Project Summary – Major Site Plan

Project: Rail Yard Mixed Use Development (2021-25)
Property Owner: P&M Realty of Concord, LLC
Address: Langdon Avenue
Map/Block/Lot: 7913Z/41, 792Z/70, and 792Z/71

TO: Beth Fenstermacher, Assistant City Planner
FROM: Gary Lemay P.E., Associate Engineer
DATE: June 8, 2021
SUBJECT: Major Site Plan Review, The Rail Yard, Langdon Ave;
Map 792Z, Lot 71; (2021-024)

Re: Traffic Engineer Peer Review
Proposed Mixed-Use Development – Langdon Avenue

Comprehensive Development Plan

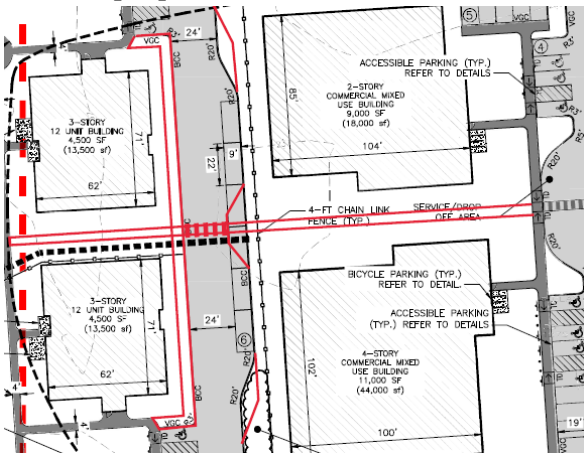
- 3. Please label Langdon Avenue on the plan.
